LAKE MICHIGAN DIVERSION

FINDINGS OF THE TECHNICAL COMMITTEE FOR REVIEW OF DIVERSION FLOW MEASUREMENTS AND ACCOUNTING PROCEDURES

October 1981

FIGURE 5 LOCKPORT POWERHOUSE SLUICE GATE LEAKAGE

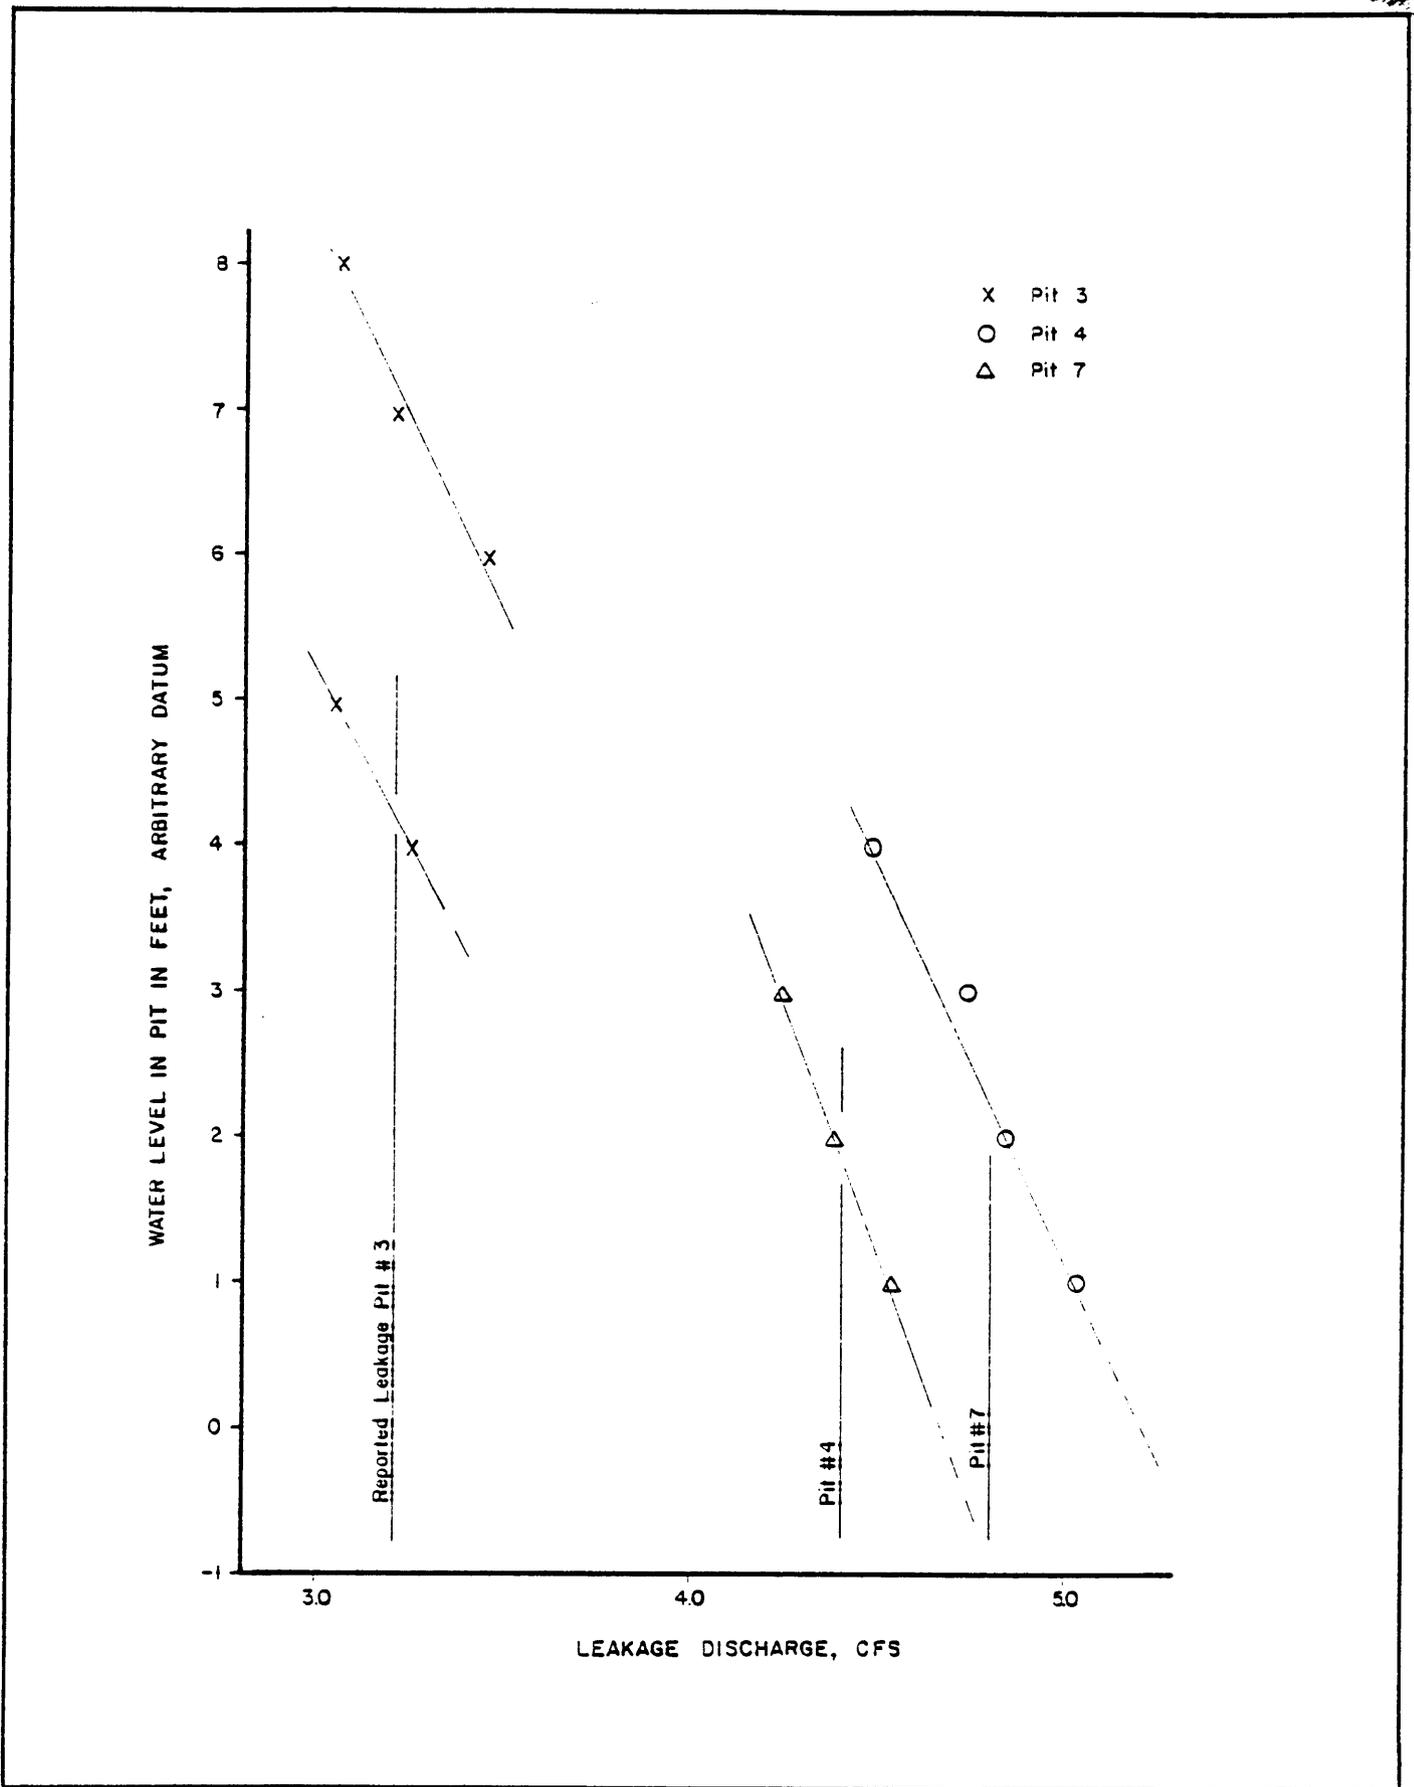
Leakage through the sluice gate will vary with the head in the canal and will function hydraulically as an orifice with a free jet discharge. However, when the draft-tube openings are blocked, water rises in the chamber creating a submerged orifice effect. Leakage is a function of the differential head and will decrease as the water level in the chamber increases. Consequently, the discharge should be computed for each time-volume increment and plotted against depth. This is illustrated in Figure 5 where the 1979 test data have been plotted.

- o The field procedures should specify that the datum of the staff gage for measuring depth of water in the chamber be set equal to the gate sill elevation.
- o The leakage rate should reflect operational conditions rather than a contrived test condition. Consequently, the analytical

procedures should be consistent with the hydraulic characteristics of the leakage through the gate. The leakage rate should be computed for each incremental depth with proper account for the correct differential head.

FIGURE 6 LOCKPORT CONTROLLING WORKS - GATE SEAT AND CANAL BED DEFINITION SKETCH (DATUM, FEET, CCD)

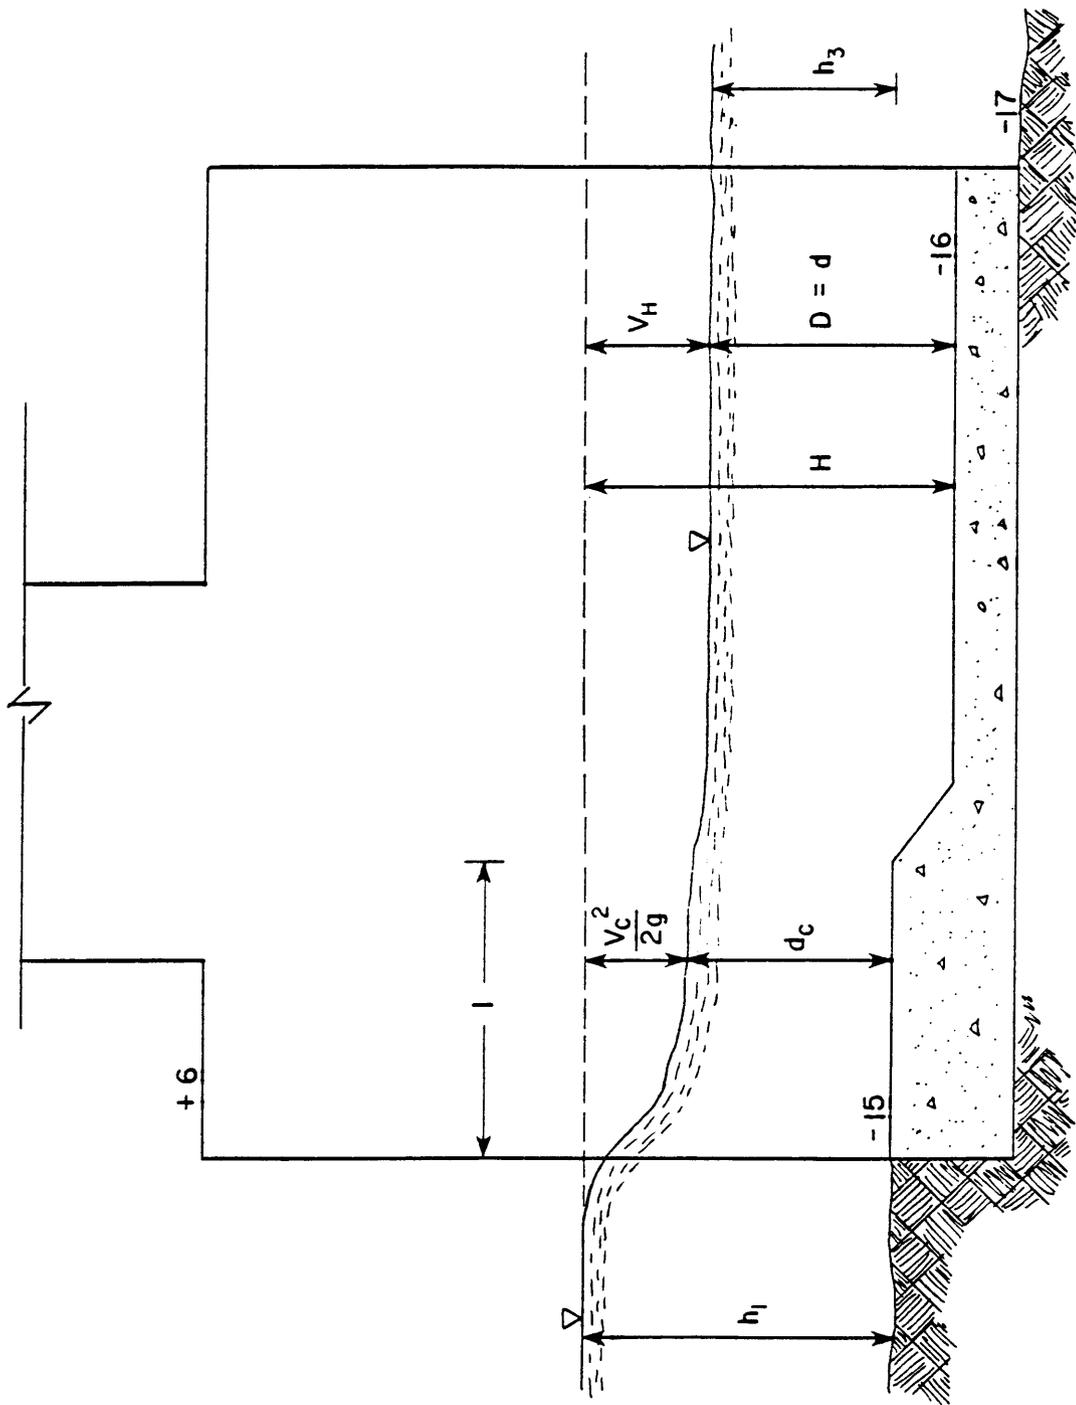
Implicit in the consideration of the structure as a broad-crested weir is that the gate seats are raised above the elevation of the canal bed. This may not be the case. A sketch, Figure 6, from a drawing of the structure, believed to have been part of the construction plans, indicates gate seat and canal bed to be at the same elevation. For this case, the structure would function hydraulically as a contracted terminal sill of zero height.

If, on the other hand, as suggested by Figure 6, the structure indeed acts as sill of zero height the discharge coefficient is no longer a function of the parameters $\frac{h}{L}$, $\frac{R}{h}$, ϵ_1 and ϵ_2 in equation 9 above. Its limiting value would be 3.09 before adjustments for the remaining parameters.

for the coefficient in equation 2. Conversely, the equivalent broad-crested weir coefficient (equation 8) used for the 1947 rating (equation 1) is 2.78. This suggests that discharge determined from the 1947 rating could possibly be on the order of 10 percent or more too low.

- o The discharge rating should be completely reanalyzed on the basis of the existing structural features, hydraulic characteristics, and operating rules. This will require a field survey to provide:
 - geometry of the gate sills and canal at the entrance to the structure;
 - location of the mooring piers;
 - canal depths in the approach area; and
 - geometry of the downstream connecting channels to the Des Plaines River.

FIGURE 7 U.S. GOVERNMENT LOCK, LOCKPORT LEAKAGE TEST 1977-1981

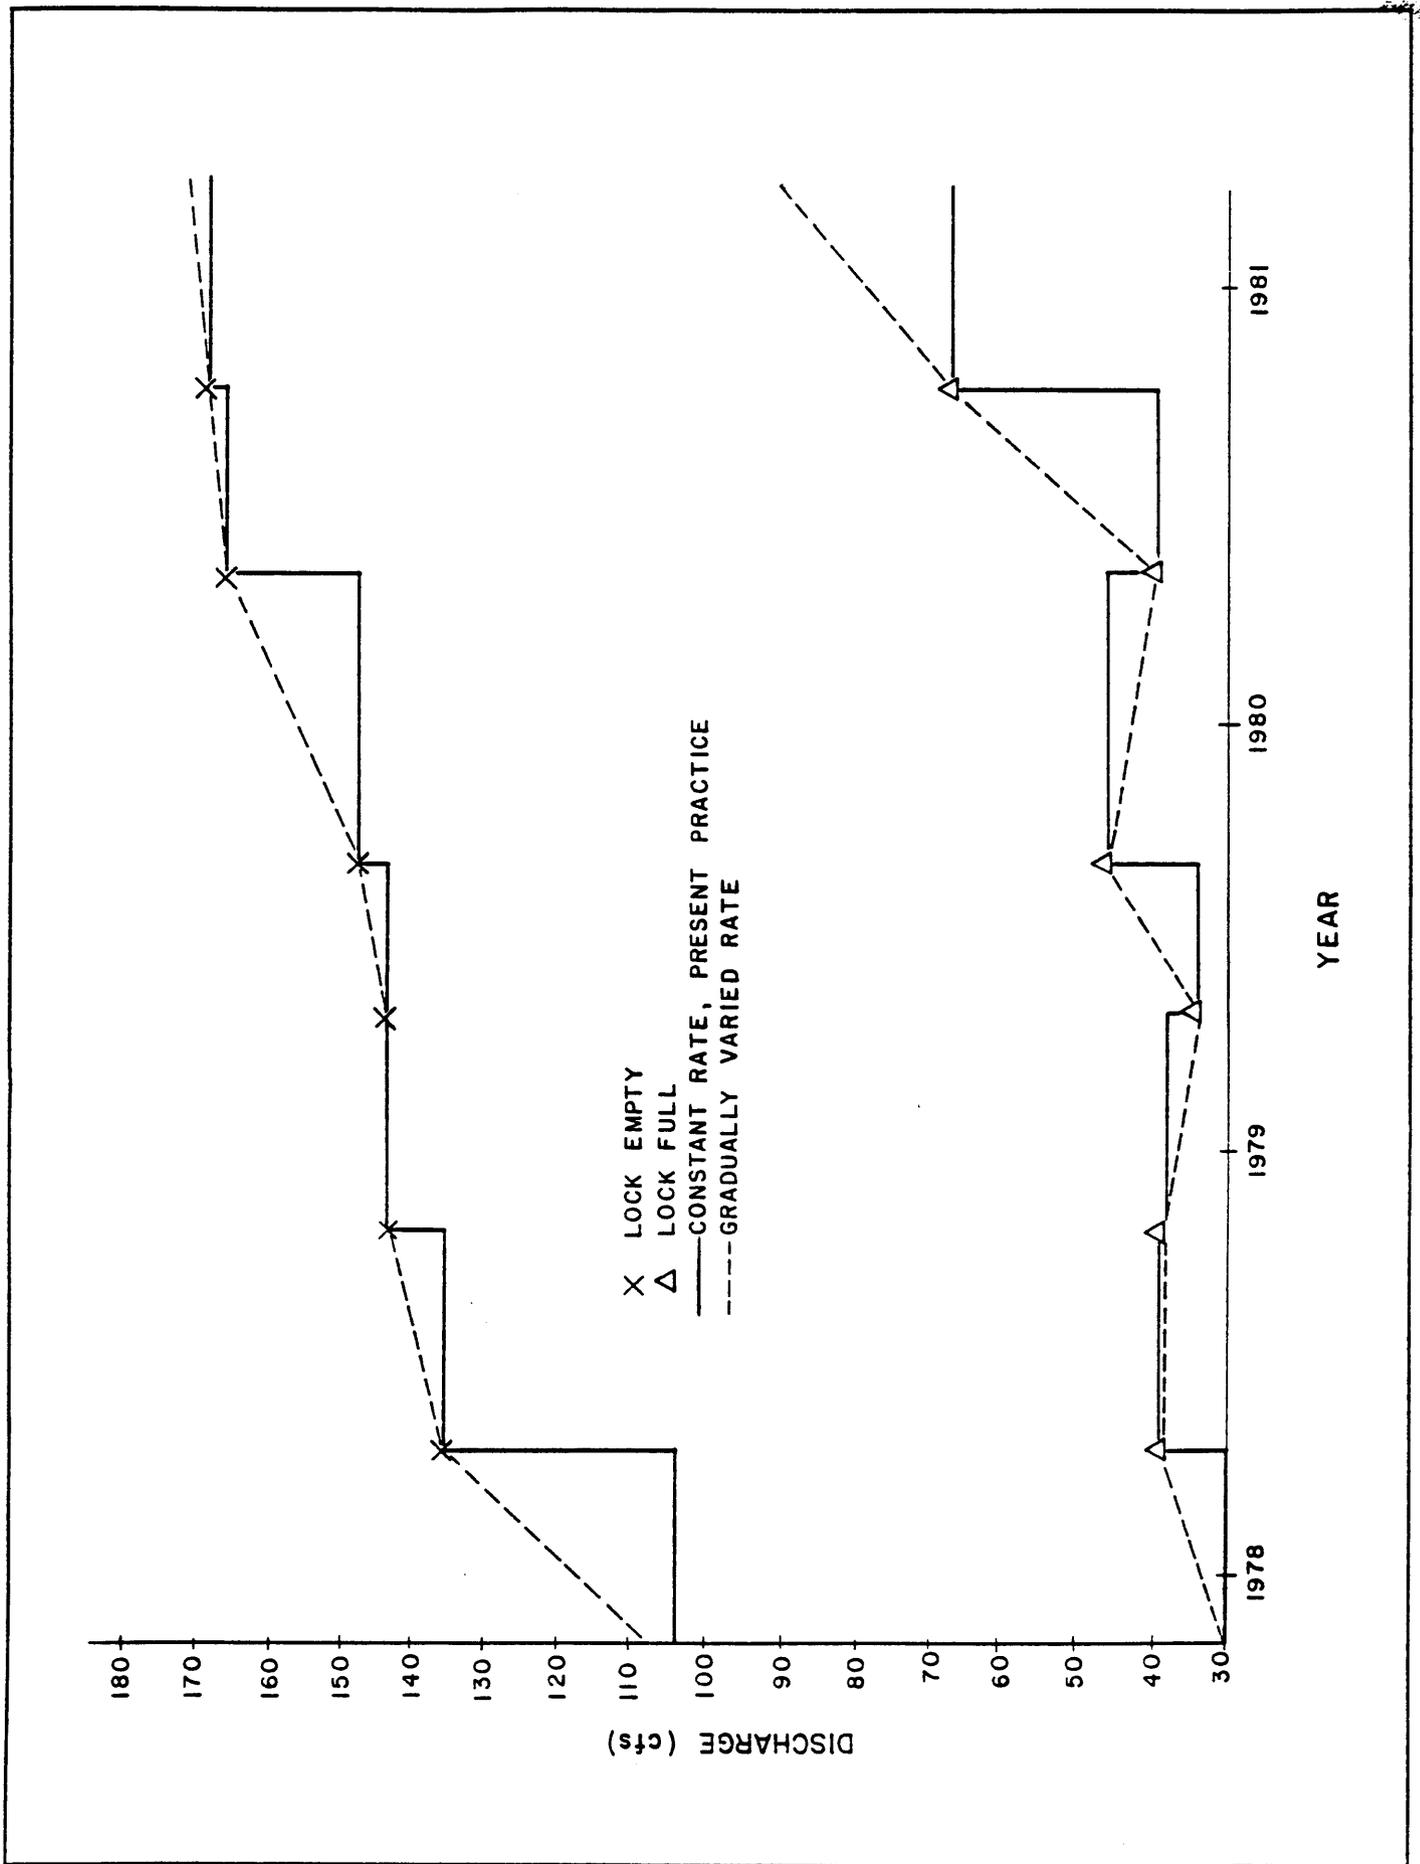
Leakage test data are plotted in Figure 7 to illustrate the assumed constant rates. The dashed lines reflect the gradually varied rate assumption. The areas defined by the solid and dashed lines, when summed and divided by two, would be an estimate of the volume difference in the assumptions. This is also an indication of the bias in the constant rate assumption.

The procedures for computing lock leakage discharge should be revised to account for the biased errors resulting from the assumptions that leakage is both constant and continuous, and for variations in upstream and downstream water levels. It should be noted that all of the previous turbine rating verification attempts, based on measurements in the upper pool, probably are in error to some degree because of the inherent errors in the present methods for determining and computing leakage through the navigation lock.
